Shorting Terminal

Reference: P5A27
Date: October 17, 2025

Affected Models/Years:	Affected Population:	Dealer Inventory:	SERVICE COMM Activation date:	Stop Sale In Effect:
2026 LEAF (ZE2)	NA	269	October 17, 2025	NO

P5A27 – 2026 LEAF DEFROST SHORTING TERMINAL

Figure 7

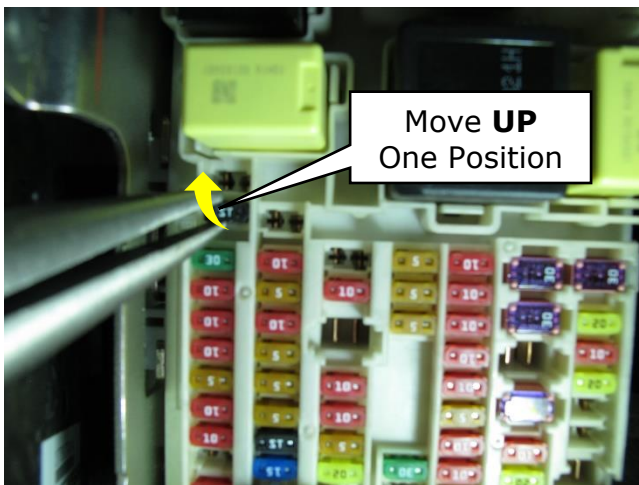
6. Move the **black** "ST" shorting terminal found in the upper left corner of the fuse block J/B **UP** one position.
- Use long needle nose pliers to remove and reinstall the "ST" shorting terminal **UP** one position
 - Refer to Figures 7 and 8 (The glovebox was removed for these photos, glovebox removal is not required for the repair)
 - Verify the "ST" shorting terminal is fully seated
